Cree® XLamp® COB LED Product Change Notification

PCN Reference Number: CREE-PCN-0956

Date Issued: January 22, 2020

Please be advised that Cree is making improvements to the voltage characteristics of XLamp® CMA1516, CMT1407, CMT1412, CMT1420, CMT1922, CMT1925, CXB1304, CXB1507, CXB1816, CXB2530, CXB2540 and CXB3050 LEDs.

CMA1516

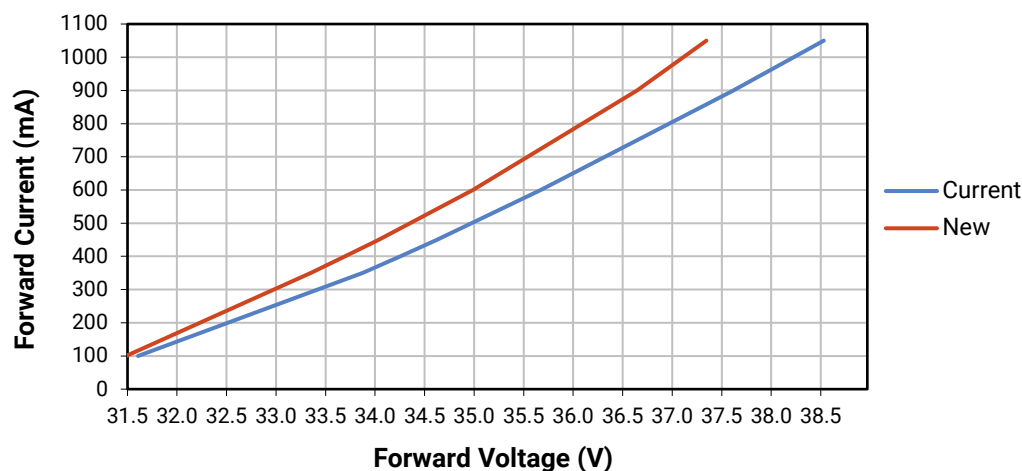
LED	Typical Forward Voltage	
	Current	New
CMA1516	35 V @ 450 mA, 85 °C	34 V @ 450 mA, 85 °C
CMT1407	34.2 V @ 200 mA, 85 °C	33.7 V @ 200 mA, 85 °C
CMT1412	34.5 V @ 200 mA, 85 °C	34 V @ 200 mA, 85 °C
CMT1420	34.4 V @ 550 mA, 85 °C	34 V @ 550 mA, 85 °C
CMT1922	34.2 V @ 600 mA, 85 °C	34 V @ 600 mA, 85 °C
CMT1925	34.2 V @ 700 mA, 85 °C	34 V @ 700 mA, 85 °C
CXB1304 9 V	8.6 V @ 400 mA, 85 °C	8.45 V @ 400 mA, 85 °C
CXB1304 18 V	17.3 V @ 200 mA, 85 °C	16.9 V @ 200 mA, 85 °C
CXB1304 36 V	34.5 V @ 100 mA, 85 °C	33.8 V @ 100 mA, 85 °C
CXB1507 18 V	17.3 V @ 400 mA, 85 °C	16.9 V @ 400 mA, 85 °C
CXB1507 36 V	34.5 V @ 200 mA, 85 °C	33.8 V @ 200 mA, 85 °C
CXB1816	35.0 V @ 450 mA, 85 °C	34.1 V @ 450 mA, 85 °C

The following graphs show the improved forward voltage vs. current curves.

CXB2530

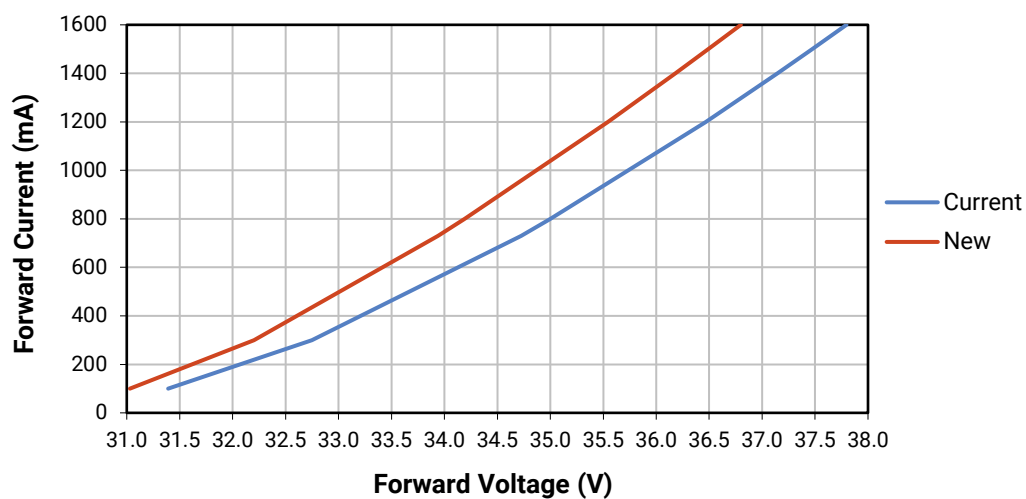
LED	Typical Forward Voltage	
	Current	New
CXB2530	35.0 V @ 800 mA, 85 °C	34.2 V @ 800 mA, 85 °C
CXB2540	34.8 V @ 1100 mA, 85 °C	34.1 V @ 1100 mA, 85 °C
CXB3050	34.8 V @ 1400 mA, 85 °C	34 V @ 1400 mA, 85 °C
